**RE: Chullora Materials Recovery Facility (SSD-10401)**

I refer to the notice of exhibition for the State Significant Development (SSD-10401) at 21 Muir Road, Chullora for the construction and operation of a materials recovery facility (MRF) with a maximum throughput up to 172,000 tonnes per annum of waste. I understood the MRF would process co-mingled and source separated dry waste from municipal, commercial and industrial sources, including paper, cardboard, glass, plastic and aluminium.

**Figure 2.** Location of sensitive receptors, recreational areas and educational facilities in the vicinity of the Proposal site and Oriental Merchant Pty Ltd site (no. 26) outlined in red (Source: Katestone Environmental, modified by Mecone).

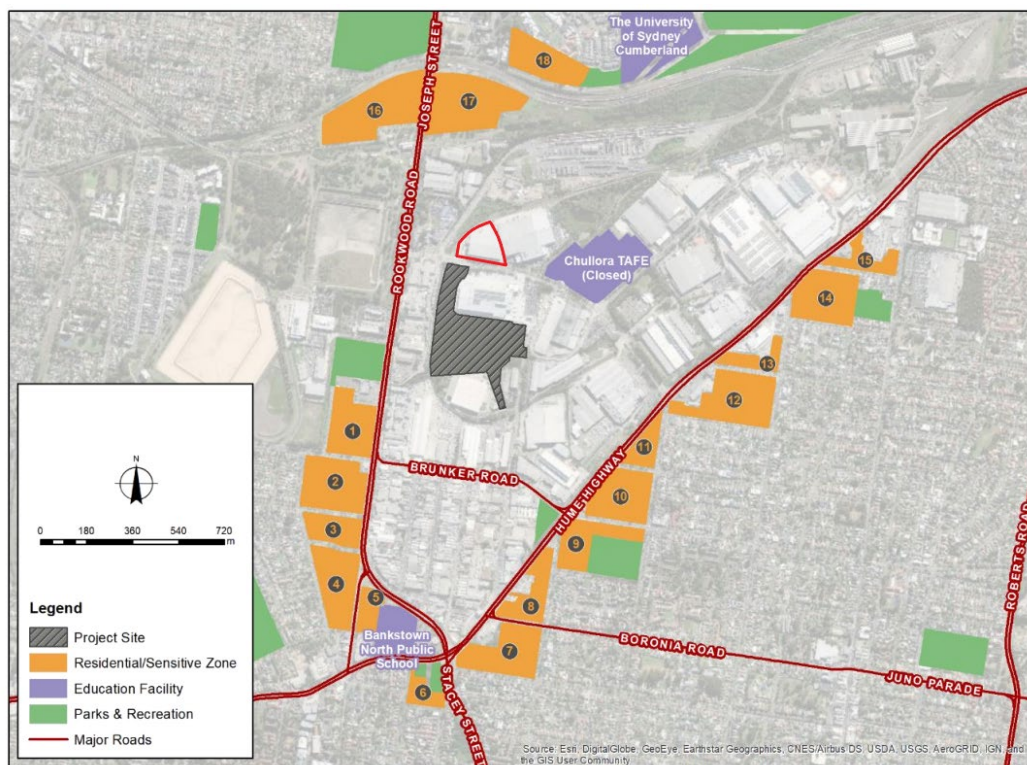
We note the above list is non-exhaustive regarding land uses. The air quality assessment by Katestone provides a thorough assessment of the impacts upon residential, educational and recreational receptors, but omits nearby, specifically adjoining land uses, including our client's site. Not only does the assessment not consider our client's site, outlined in red on Figure 1 below, but does not include an assessment of all adjoining land uses, which include many sensitive receptors, including commercial premises, such as food and drinks premises. We believe this to be a significant omission in the reporting and overall assessment that needs to be properly considered.

Further to the above, while the air quality assessment acknowledges the location of known sensitive receptors, it fails to provide for an assessment of likely future receptors. The air quality assessment must have regard to the future development potential of adjoining sites and wider area. The proposed MRF will likely have adverse impacts on the future development of surrounding land, which the air quality assessment fails to consider.
